DOCUMENT CHANGE NOTICE (DCN)

DOCUMENT No. (DOC-REV-GP. ID)	TITLE	NEW REV.
D970506-A-D	LOS2 Structure Assembly (Beamsplitter)	B
D970545-A-D	LOS2 Bracket, Sensor/Actuator	B
D970546-A-D	LOS2 Safety Stop Bracket, Front	B
D970547-A-D	LOS2 Safety Stop Bracket, Rear	B
D970548-A-D	LOS2 Bracket, Side Sensor/Actuator, Left	B
D970549-A-D	LOS2 Adapter Plate	B
D970570-A-D	LOS2 Bracket, Side Sensor/Actuator, Right	B

DATE	8-17-98	TITLE	LIGO PROJECT
DRWN	C. Conley	SCALE	1:1
CHKD		SHEET	1 of 6
ENGR		UNLESS OTHERWISE SPECIFIED:	
APPD		DIMENSION LIMITS ARE (inch/len)	
		TOLERANCES ARE:	
		X.XXX: ± 0.01	
		X.XX: ± 0.03	
		X.X: ± 0.1	
		NEXT ASSEMBLY: D970505

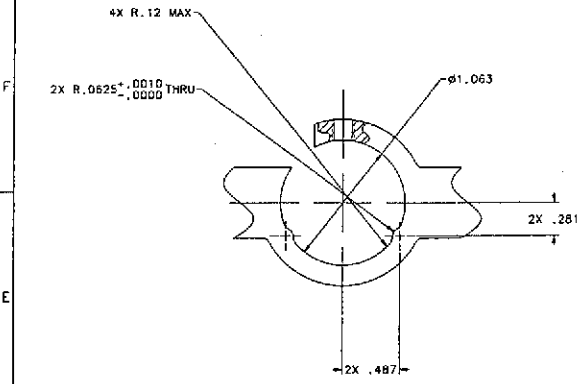
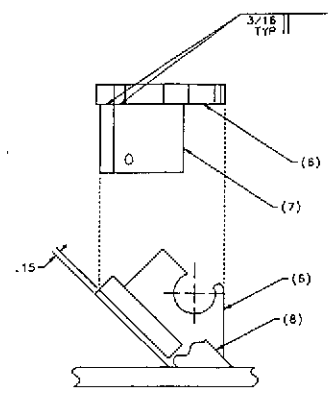
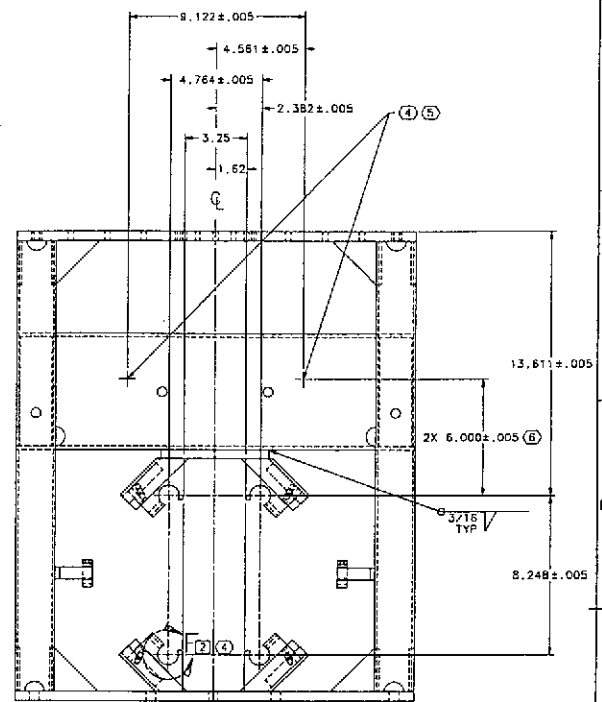
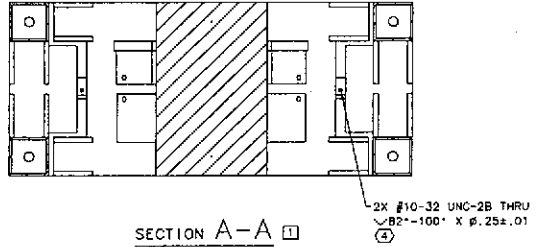
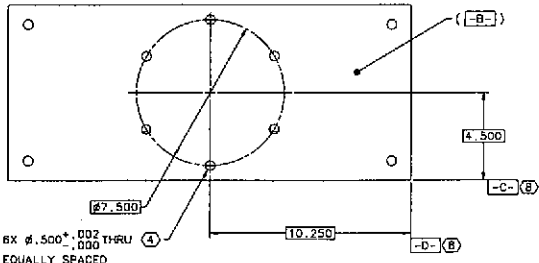
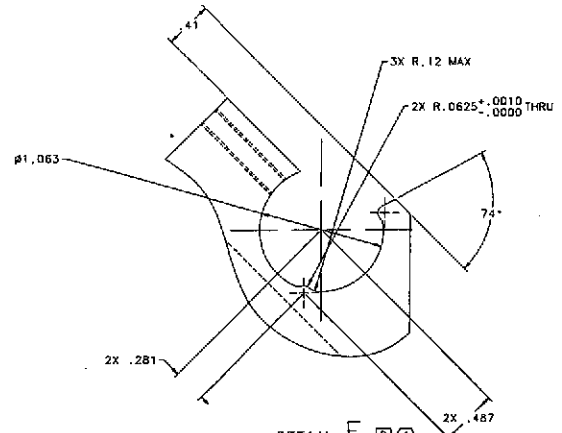
1) D970506 sheet 1:

Changed dimensioning scheme for vertical locating of the upper two sensor/actuator brackets (items 6).

2) D970506 sheet 1:

Changed tolerance on vertical locating dimension of the side sensor/actuator brackets (item 9 & item 10) from +/- .03 to +/- .06.

REASON FOR CHANGE: 1) To insure required locating accuracy of items 6. 2) Necessary due to 1). 3) To improve venting, avoid air traps. 4) Added material to accomodate loosened tolerance in 2).

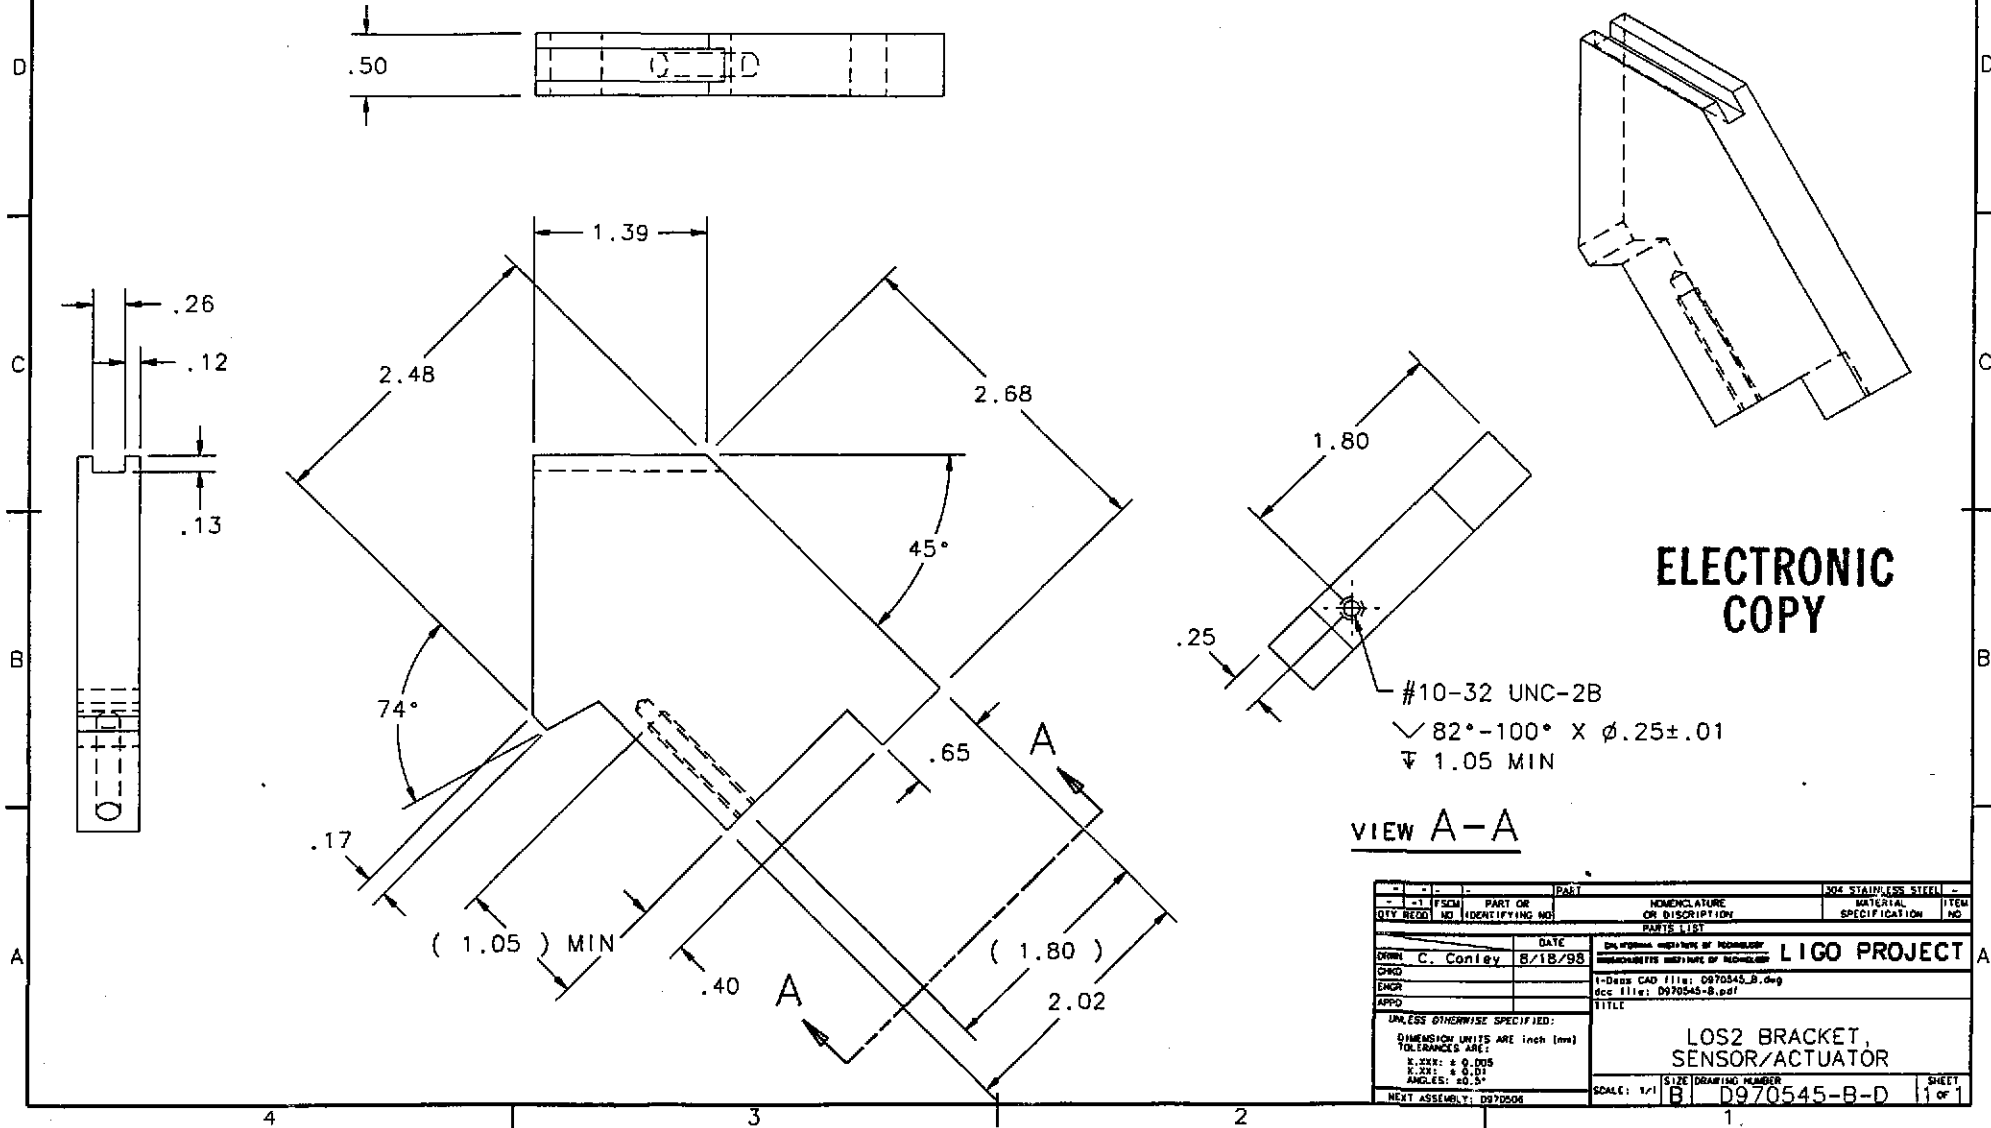
3) D970545 through D970570:

Removed vent holes and added vent slots.

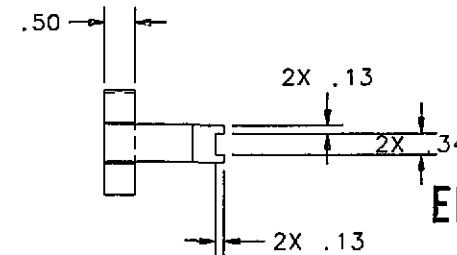
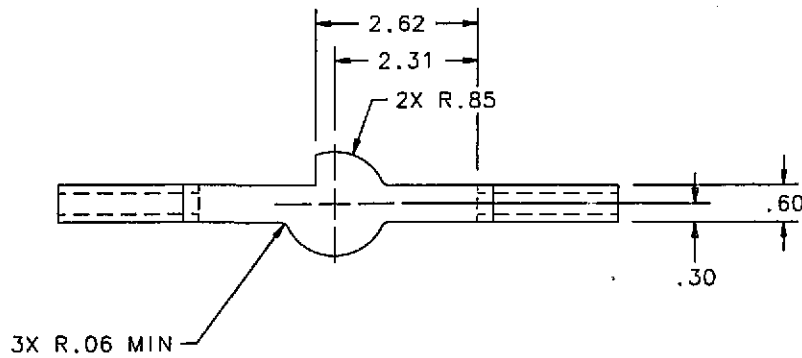
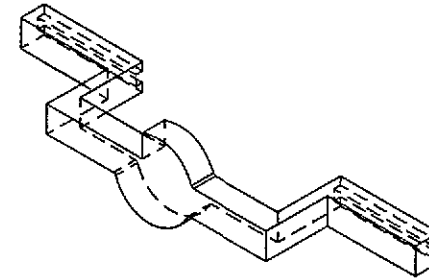
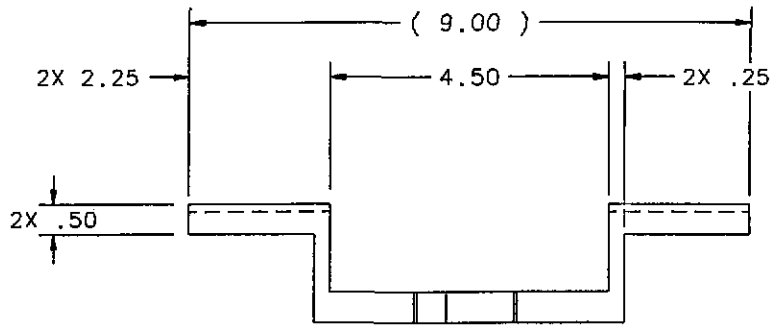
4) D970548 & D970570:

Increased outer radii of the OSEM holding feature from .71 to .85.
